# PIC24FJ64GA104 FAMILY

## PIC24FJ64GA104 Family Silicon Errata and Data Sheet Clarification

The PIC24FJ64GA104 family devices that you have received conform functionally to the current Device Data Sheet (DS39951C), except for the anomalies described in this document.

**FIGURE 2-3 FREQUENCY vs. ESR PERFORMANCE FOR SUGGESTED VCAP**

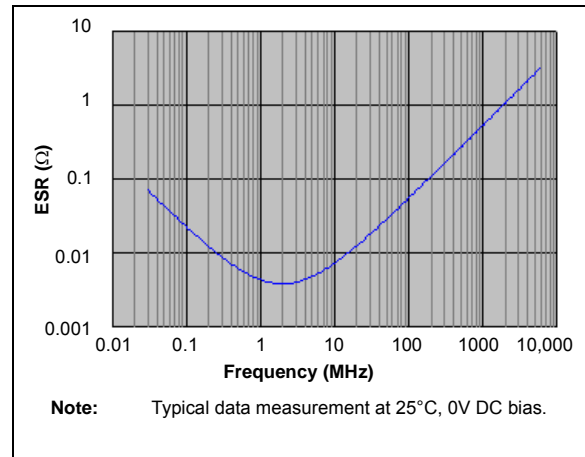
**Section 2.4 Voltage Regulator Pins (ENVREG/ DISVREG and VCAP/VDDCORE)** has been replaced with a new and more detailed section. The entire text follows:

When the regulator is enabled, a low-ESR (< 5Ω) capacitor is required on the VCAP/VDDCORE pin to stabilize the voltage regulator output voltage. The VCAP/VDDCORE pin must not be connected to VDD and must use a capacitor of 10 μF connected to ground. The type can be ceramic or tantalum. Suitable examples of capacitors are shown in [Table 2-1](#). Capacitors with equivalent specifications can be used.

Designers may use [Figure 2-3](#) to evaluate ESR equivalence of candidate devices.

**FIGURE 2-4 DC BIAS VOLTAGE vs. CAPACITANCE CHARACTERISTICS**

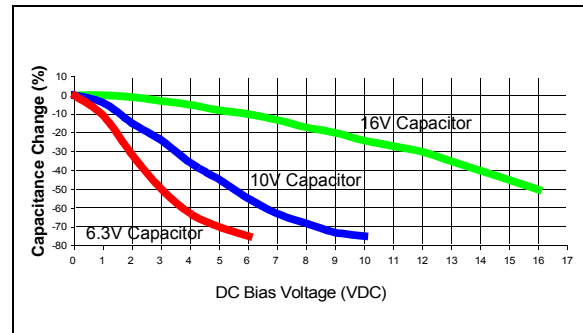
In addition to temperature tolerance, the effective capacitance of large value ceramic capacitors can vary substantially, based on the amount of DC voltage applied to the capacitor. This effect can be very significant, but is often overlooked or is not always documented.

A typical DC bias voltage vs. capacitance graph for 16V, 10V and 6.3V rated capacitors is shown in Figure 2-4.

When selecting a ceramic capacitor to be used with the internal voltage regulator, it is suggested to select a high-voltage rating, so that the operating voltage is a small percentage of the maximum rated capacitor voltage. For example, choose a ceramic capacitor rated at 16V for the 2.5C core voltage. Suggested capacitors are shown in Table 2-1.
